Access Audit Report February 2021

Access Assessment Report

Prepared for Sunna Life Tutoring Academy.

463 Chapel Road, Bankstown NSW 2200, Lot: D, DP: 19584

Photos showing the internal view of the main pedestrian entry door.

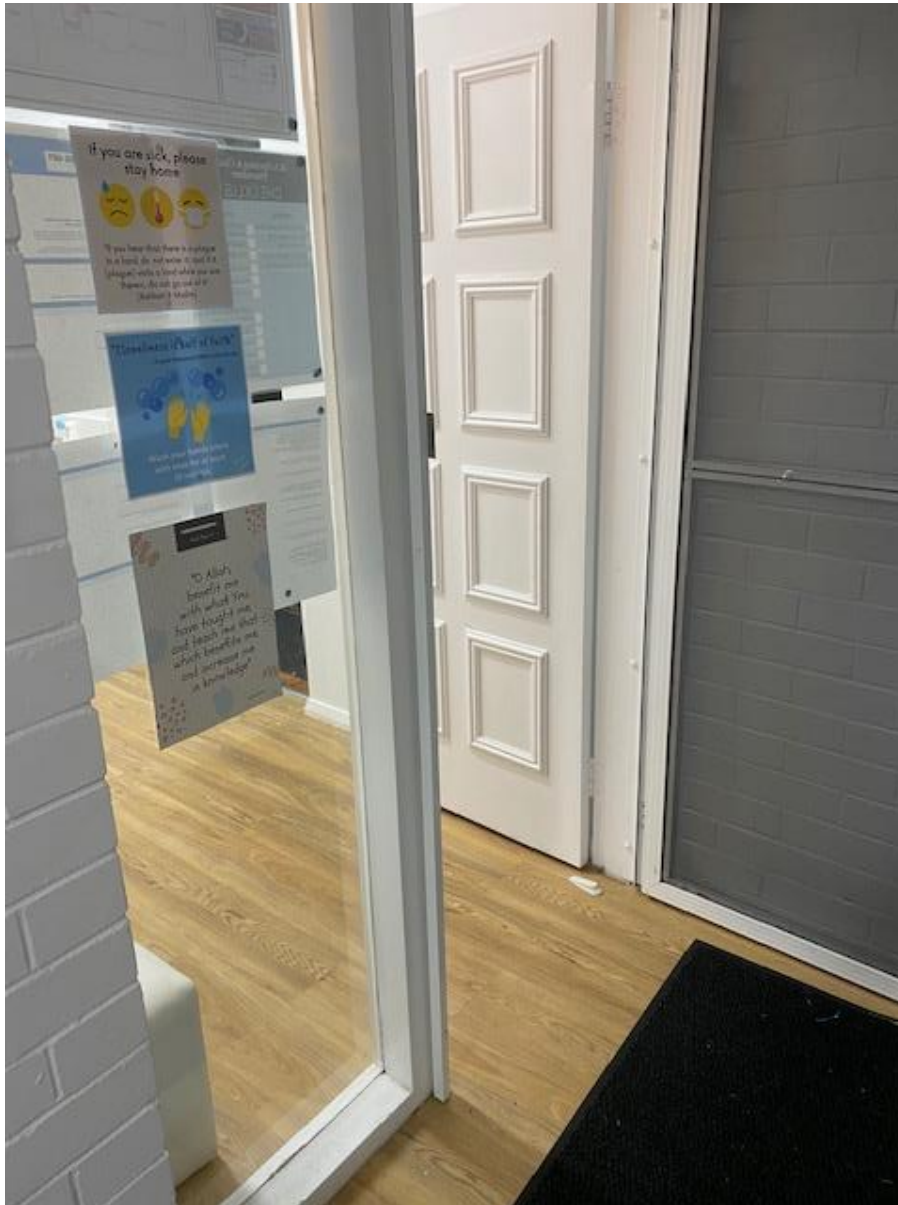
Note: the fixed glass panel to be removed and replaced with a swinging door in the direction of egress, the existing door is to be re-hung to also swing in the direction of egress as per NCC-2019 requirements.

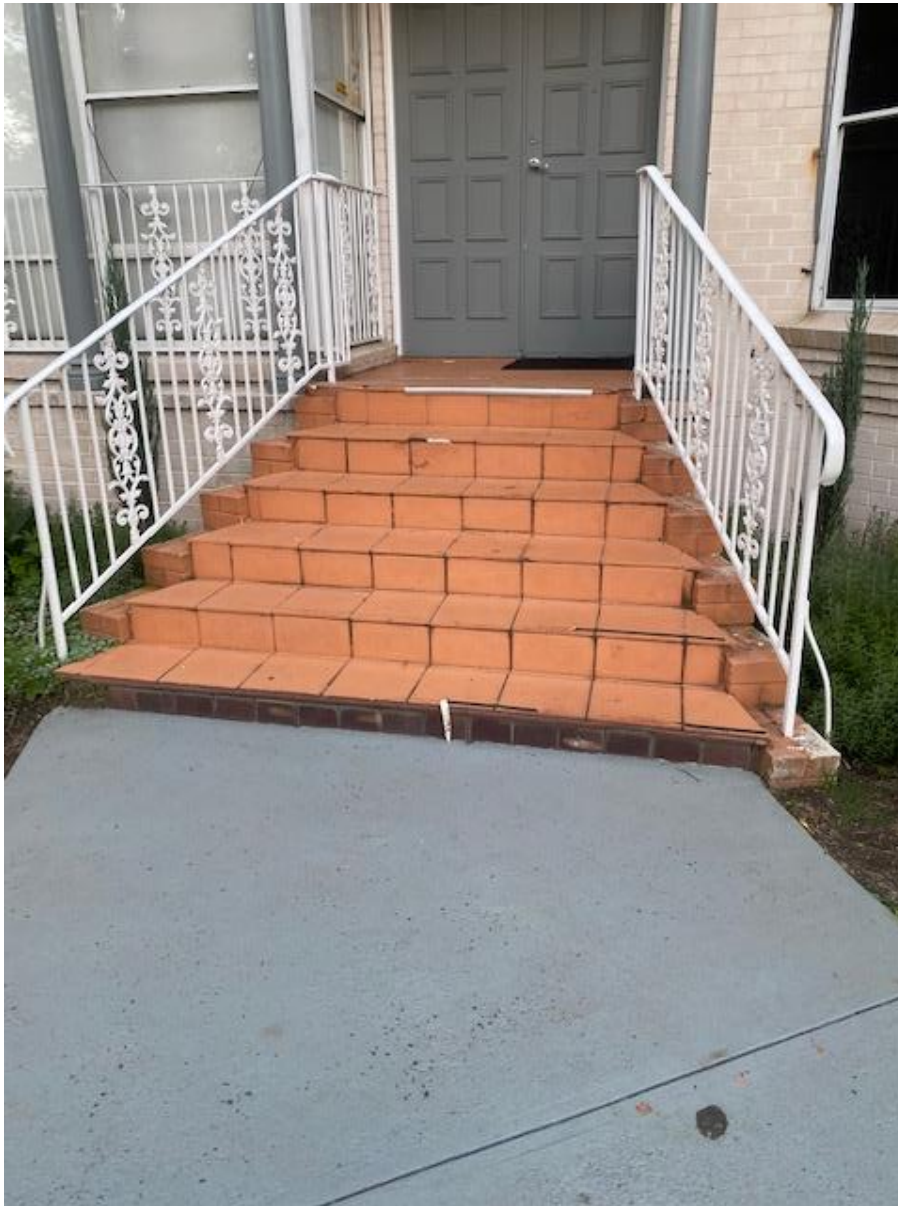
Photo showing principal pedestrian entrance requiring a chair lift.

Another photo showing the principal pedestrian entrance requiring a chair lift. Accessible Entrance signage will also be required for this area.

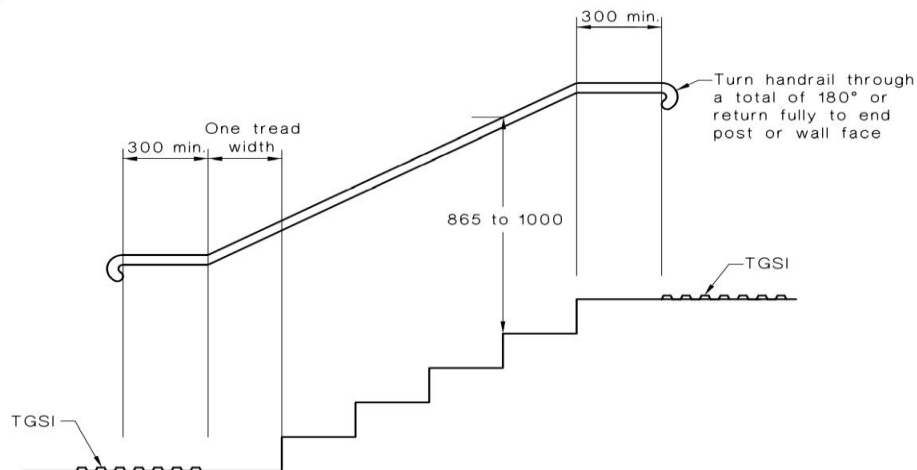
Another photo showing the principal pedestrian entrance requiring a TGI and 30% non-slip Luminous Contrast strips to the edging of all steps and requiring the replacement & rectification of loose tiles. Also TGI are required at the bottom just before the stairs and at the top also just before the stairs.
